AMTA Submission

Draft allocation and technical
instruments for the 3.4/3.7 GHz bands
auction
Consultation Paper

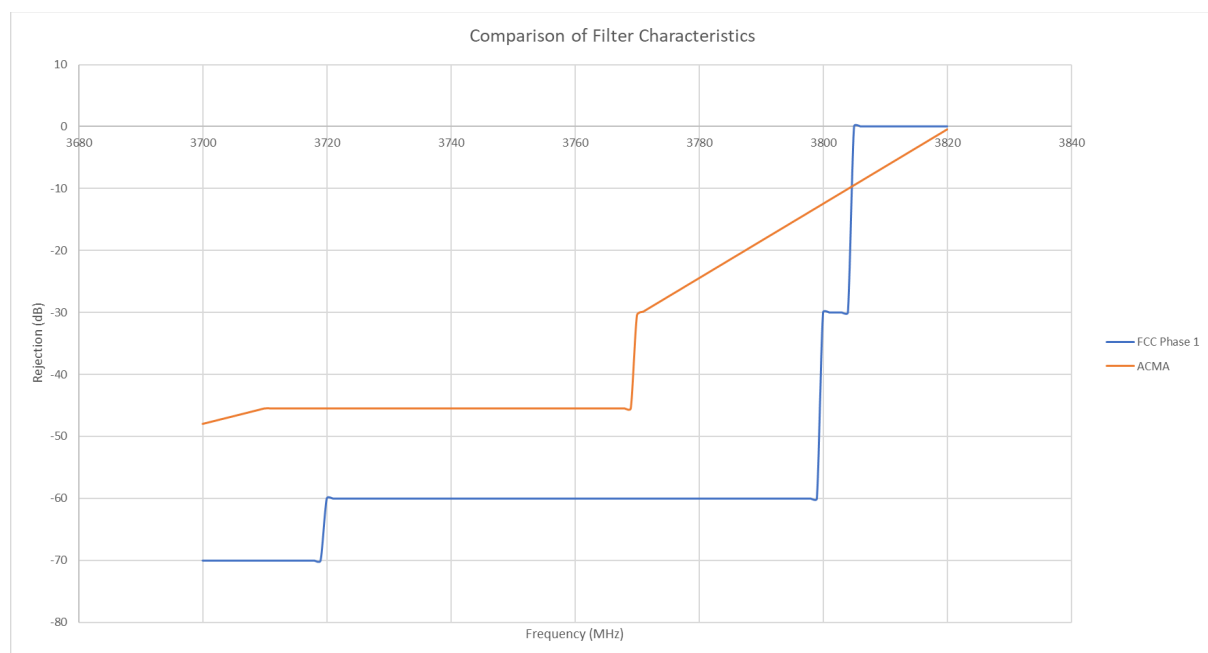
Finally, as supported by the results of the Canadian study, *“the results of simulations demonstrated that limiting the vertical scanning below the horizon had little impact when the combined digital and mechanical tilts were already kept below the horizon”*¹⁰.

As such, we submit that the interim mitigation iii. *“requiring WBB base station antennas to point or scan below the horizon only”* should be amended to delete the words *“or scan”*. The mitigation could benefit from clarification that *“to point”* refers to the aggregate of the mechanical and fixed electrical tilt—noting that the fixed electrical tilt is different to the dynamic vertical scanning.
